Conductor and Cable Summary and Comparison of MQXFB08 Witness Sample Results

Technical Meeting to Review Coils for MQXFB08, 6 November 2024

CR151 Performance at 1.9 K

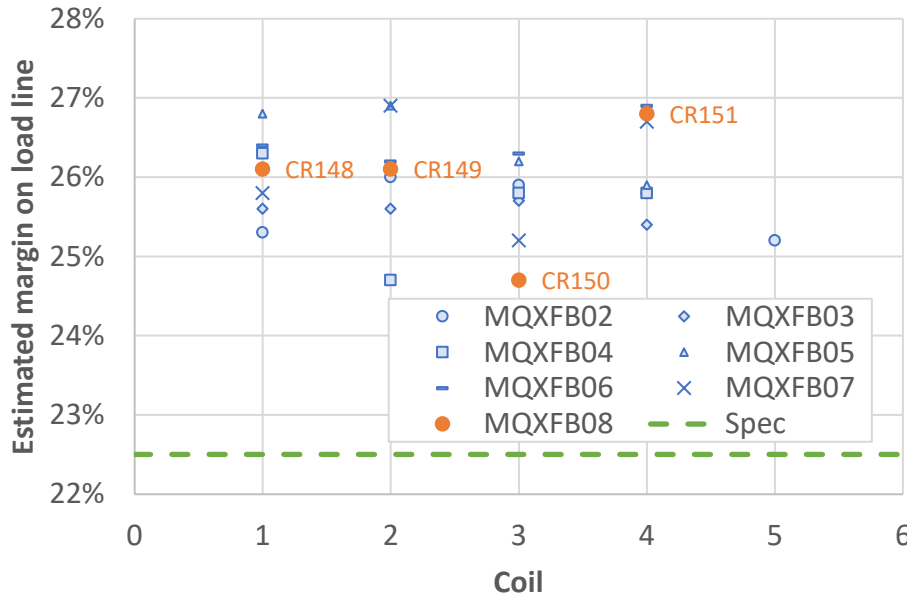
- I_c parameters for the witness samples at 1.9 K have been estimated assuming the typical temperature scaling for MQXF wire

- With those values, margin at 1.9 K would be **26.8 %**

At 1.9 K	$I_{c,SS}$ (A)	$I_{op}/I_{c,SS}$ (%)
Min	22488	73.2%
Avg	22664	72.7%
Max	22957	71.7%

Load Line Margin

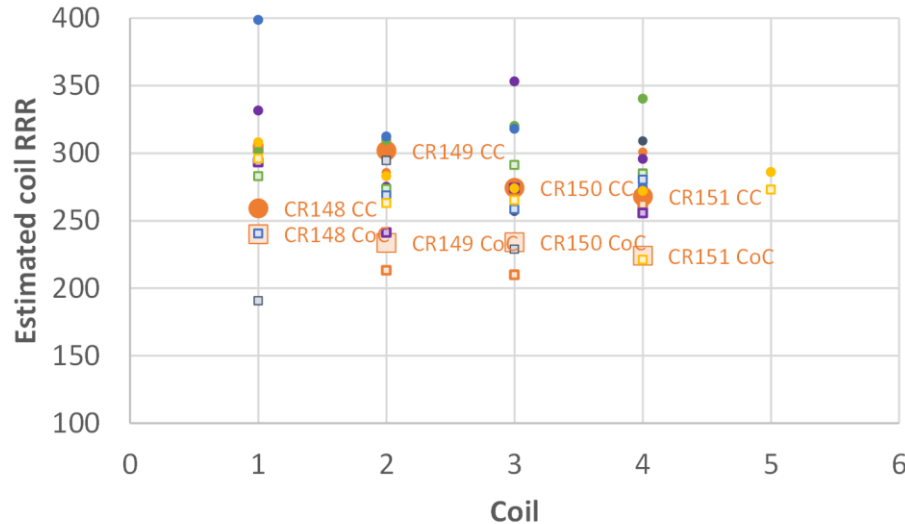
- Large margin on load line of ~26 %
- Consistent in mean and spread with recent coils

Estimated Coil RRR

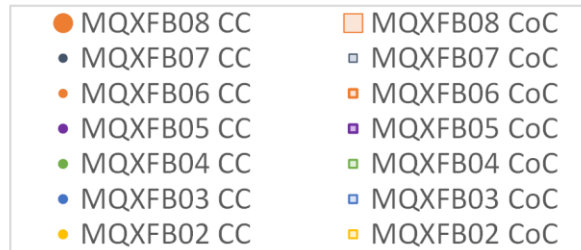
- Large RRR margin
- Connection side (CC) has higher RRR
- All values within the range of other recent coils

Effect of HT/Furnace on Round Wire I_c

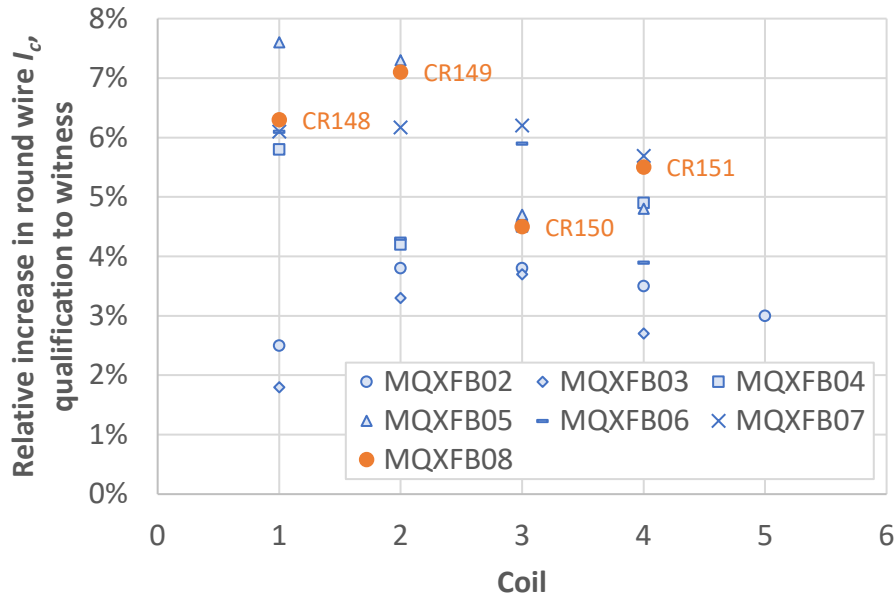
- I_c consistently slightly higher for witness samples (HT in building 180) than qualification samples (HT in building 163)
- In a consistent range for recent coils

Cabling Degradation of I_c

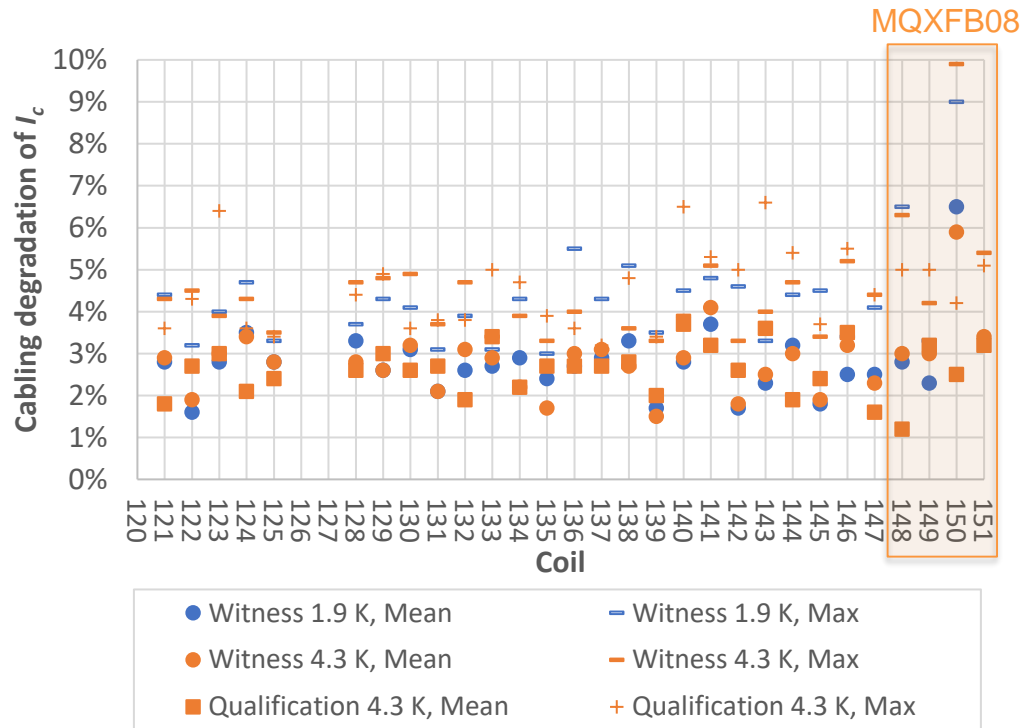
- Cabling degradation of I_c is within the 5 % specification for **qualification** samples of all coils
- Mean cabling degradation is also <5 % for **witness** samples
 - Except the CR150, for which degradation values are available for only two strands, one of which shows anomalously high degradation
 - Excluding this outlier, mean
- Otherwise, consistent and conforming degradation as assessed from witness samples across all recent production, both at 1.9 K and 4.3 K
- Excluding outliers above: mean cabling degradation ~3 %
